IIoT Product End-of-Life Notice

End of Life, Last Time Buy and Replacement Announcement

For immediately release, Advantech is announcing the End of Life (EOL) of **PCIE-1753-AE**. The relative replacing models are as below list. Customers who had purchased this Part Number either to purchase any additional rules or migrate to the new replacement models if possible before the EOL's shipment date.

Product Part Numbers Affected by This Announcement

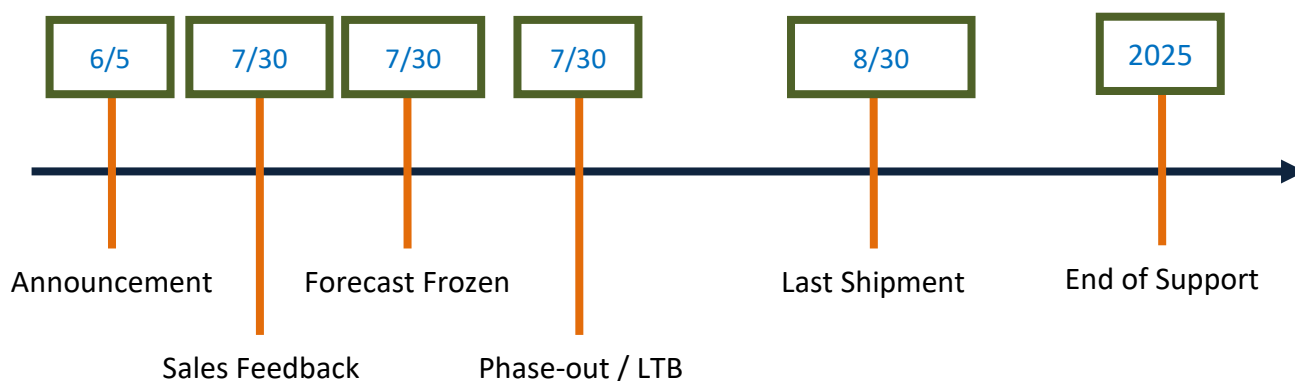
Reason for the Change

Key component FPGA long Lead Time: 1410021380 (IC XC6SLX25T-2CSG324C)

Impact	PCIE-1753-AE	PCIE-1753-B
Pin assignment	The same as AE version	
Hardware spec	The same as AE version	
Driver support	Need to upgrade driver	
API Support	The same as AE version

End of Life Product	Suggest Replacement Product	Sample Available Date
PCIE-1753-AE	PCIE-1753-B	2023/4/10
